SHOREHAM NUCLEAR POWER STATION

Shoreham Nuclear Power Station - Unit 1
Docket No. 50-322

Enclosed herein are ten (10) copies of each of the following field changes/revisions to the Preservice Inspection Program for the Shoreham Nuclear Power Station - Unit 1:

ISI FIELD CHANGE AUTHORIZATION

FIGURE 2. ULTRASONIC CALIBRATION STANDARD 04-080S-SSF.

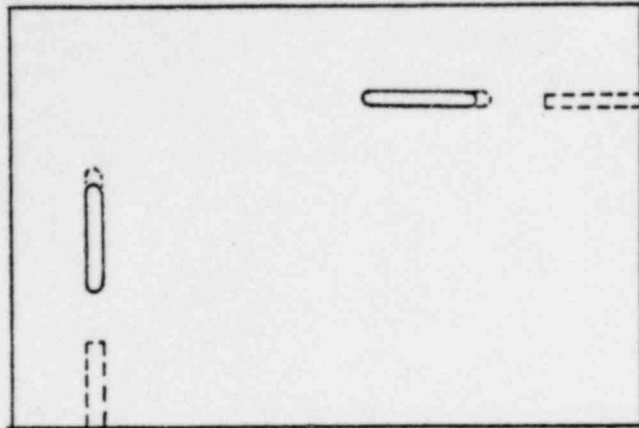
Rev. No.	Date	Description	Reason	Prepared by	Approved by	
					NES	LILCO
1	7/3/79	<p>Changed Ref. Std. No. to 04-080S-SSF in para. 6.2(5) and throughout procedure.</p> <p>Added additional column "Notch Depth (%T)" to Figure 2.</p> <p>Changed note in Fig. 3 to read "..per Section 8.4."</p>	<p>To incorporate LILCO review comments.</p> <p>CRA-910</p>	<p>V. Prantis</p> <p><i>V. Prantis</i></p>	<p>NES</p> <p><i>FC</i></p>	<p>LILCO</p> <p><i>MJS</i></p> <p><i>7/10/79</i></p>

Calibration Block ID	Nominal O.D.	Wall T	Hole Dia.	Hole Location	Hole Length	Material	Notch Depth (%T)
04-080S-SSF	4.50"	.367"	3/32	1/2T	1.5"	SS	10%T
